Committee on Tidal Hydraulics

Minutes of the 104th Meeting

18-20 April 1995

John F. Baldwin Project, Phase III

Comparison of Maximum Salinity Impacts

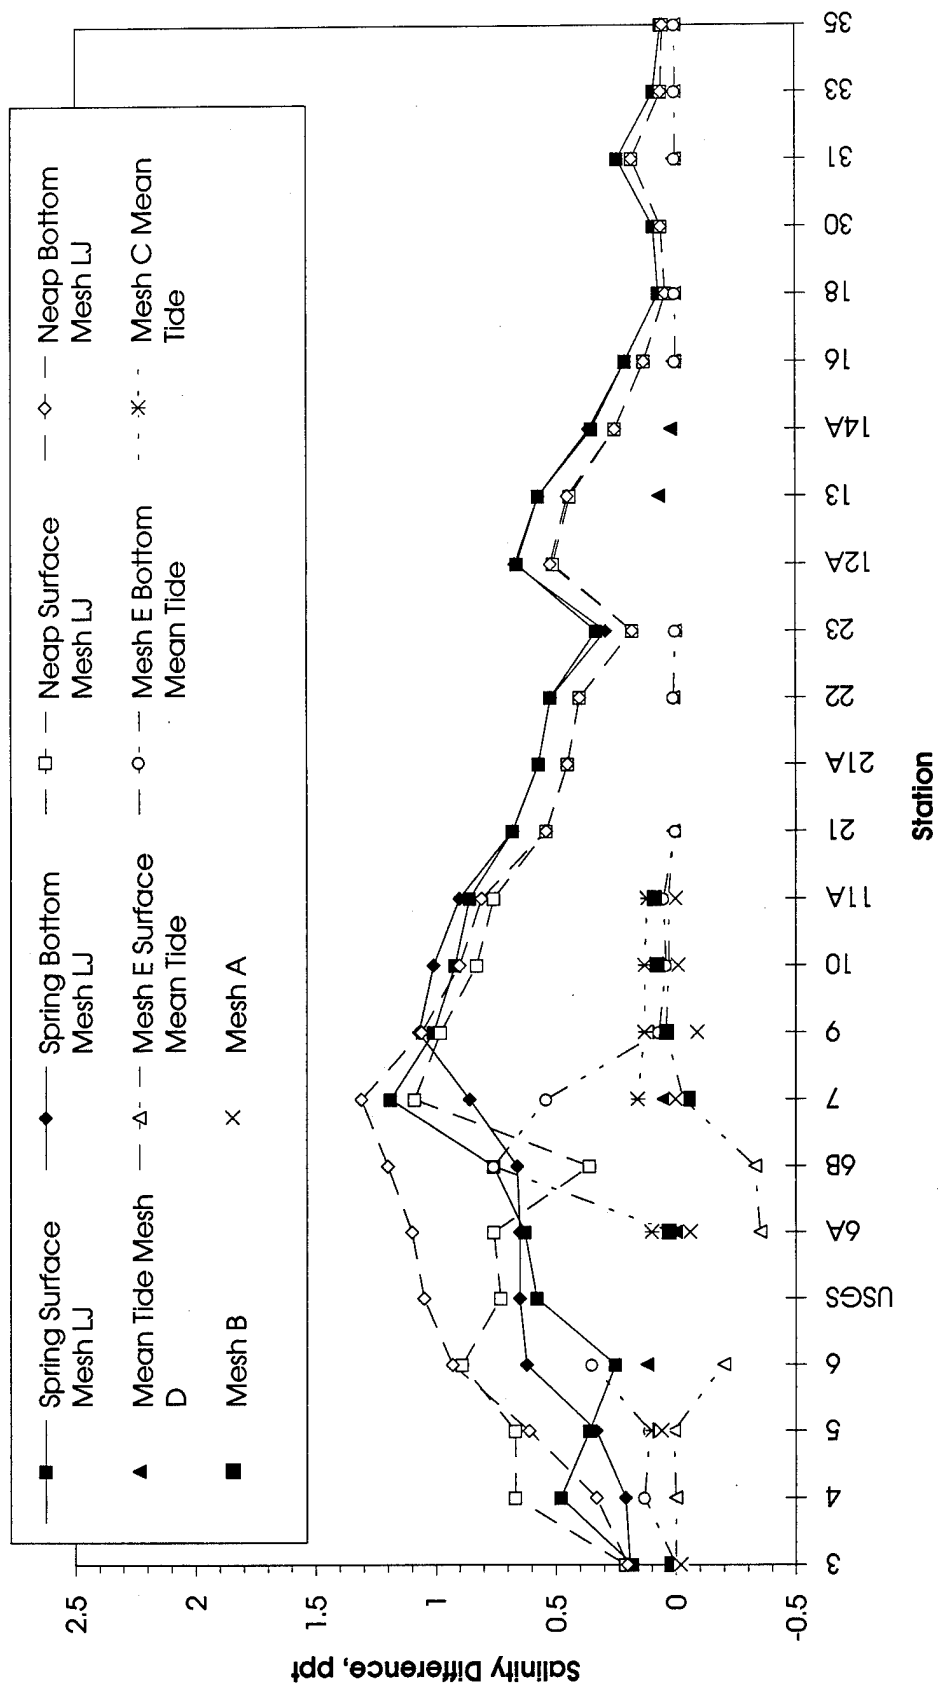
19. Enclosure 3 shows JFB salinity change results from the several numerical models. Models A-E showed maximum salinity change effects of the JFB project to be from about 0.4 ppt fresher (at the surface in Carquinez Strait with Model E) to 0.8 ppt saltier (near bottom in Carquinez Strait with Model E). At Chipps Island, a standard measuring point in prior studies, Models A-E showed maximum salinity increases of about 0.1 ppt, whereas Model LJ indicated an increase of about 0.9 ppt. Base salinities at the Chipps Island station were about 5 ppt. Mr. McAnally showed a series of video clips displaying animated salinity contours.

20. The lower salinity change predictions of numerical Models A-E are consistent with the physical Bay Model predictions of JFB effects, but since those numerical models were verified to the

physical model, agreement is not independent confirmation of the effect. The following are possible reasons for the differences of Model LJ:

- a. The Model LJ test was the only one in the full series of physical and numerical tests to use a neap range to spring range variable tidal boundary condition instead of the repetitive 19-year mean tide. It has been recognized in some prior physical model studies (e.g., Chesapeake Bay, Columbia River, Cape Fear River) that salinities with neap-spring tides can be significantly different from the artificial repetitive mean tide. If San Francisco Bay responds in a similar nonlinear fashion, the Model LJ results could be more realistic than previous test results.

- b. Models A-E were verified to the physical model channel salinity results, and Model LJ is the first of the numerical models in this series to generate fully independent results. The difference may be indicative of the range of accuracy of both the physical and numerical model predictions, or indicate error in either model.

- c. The Model LJ test from which these differences were taken may not have been fully spun up—the salinity values were not necessarily independent of the initial test conditions. If base and plan tests were approaching full spin-up at different rates, the difference between base and plan salinities could be in error.

- d. The two models may be using slightly different bathymetric data.

31. Mr. Jaime R. Merino, South Pacific Division, noted that the numerical model video clips showed an apparently sudden increase in surface salinities in Carquinez Strait. He suggested that sequence be examined in detail to see if it reflected a numerical instability.

21. The San Francisco District has tasked WES with conducting additional tests to explore these potential explanations of the model differences. The initial test of this series—running Model LJ with the same boundary conditions as the physical model, including the mean tide—is underway and will be complete within a few weeks.
